SILVER PINES SUBDIVISION

<u>Engineering Comments:</u> Must comply with the Mobile County Flood Damage Prevention Ordinance.

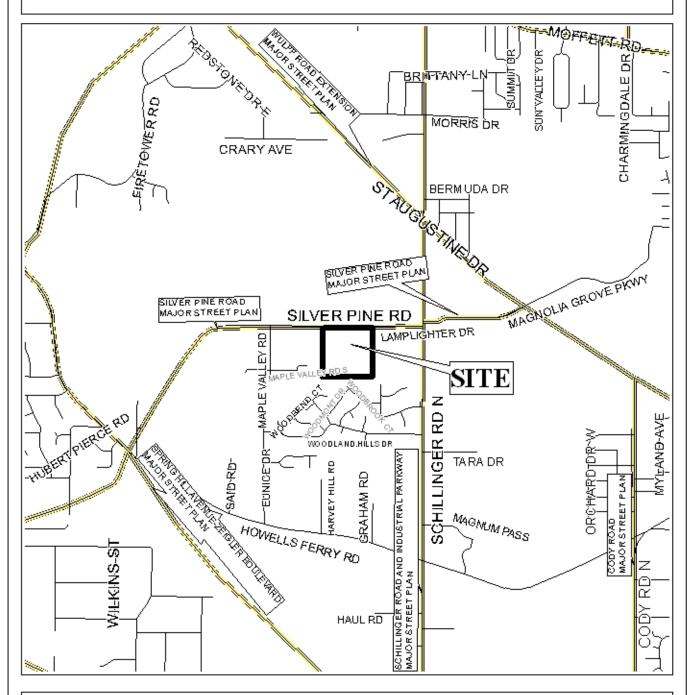
Detention and common areas are shown on the plat, labeled accordingly, and accompanied by a note on the final plat stating that their maintenance will be property owners' responsibility. However, there are two islands located at the entrances to the subdivision which are not labeled as common areas. The county does not accept maintenance of such islands, therefore they should be labeled as common area.

It should also be pointed out that there is a portion of the site that is neither a lot nor a common area, but is simply noted as "DIRT DRIVE CURRENTLY IN USE BY OTHERS". While it is used by others, it is apparently part of the parcel in question and must have some formal designation. There may also be some question about this area either being considered a prescriptive right-of-way, or even being adversely possessed by the adjacent property owners. This issue should be resolved prior to approval.

The site abuts a street stub to the West (Maple Valley Road South), and should provide a connection to that street stub when Maple Valley Road South is constructed to County Standards. Additionally, a street stub should be provided to the large undeveloped tract adjacent to the East. While this tract has frontage on both Silver Pine Road and Schillinger Road North, the provision of a street stub would allow an additional access to Schillinger when that site is developed, as well as allow for future connectivity from Schillinger Road to Howells Ferry Road.

Based on the preceding, it is recommended that this application be heldover until the March 15 meeting to allow the applicant to revise the plan and illustrate the following:

- 1) revision of the dedication along Silver Pine to reflect 20' from centerline;
- 2) resolution of issues relating to the "DIRT DRIVE CURRENTLY IN USE BY OTHERS":
- 3) provision of street stubs to the East and West;
- 4) labeling of the islands as common areas;
- 5) illustration of proposed phasing of the subdivision

The applicant has submitted a revised plat addressing the issues that necessitated the holdover.

Based on the preceding, it is recommended that this application be approved subject to the following conditions: 1) submission of a letter from licensed engineer certifying compliance with the City of Mobile's stormwater and flood control ordinances must be provided to the Mobile County Engineering Department and the Planning Section of Urban Development prior to signing and recording of the final plat; 2) placement of a note on the final plat stating that any lots that are developed commercially and adjoin residentially developed property must provide a buffer, in compliance with Section V.A.7 of the Subdivision Regulations; 3) all streets must be constructed to county standards and dedicated; 4) placement of a note on the final plat stating that lots 1, 57-64, and 92 are denied direct access to Silver Pine Road; and 5) placement of a note on the final plat stating the maintenance of all common areas shall be the responsibility of the property owners association.
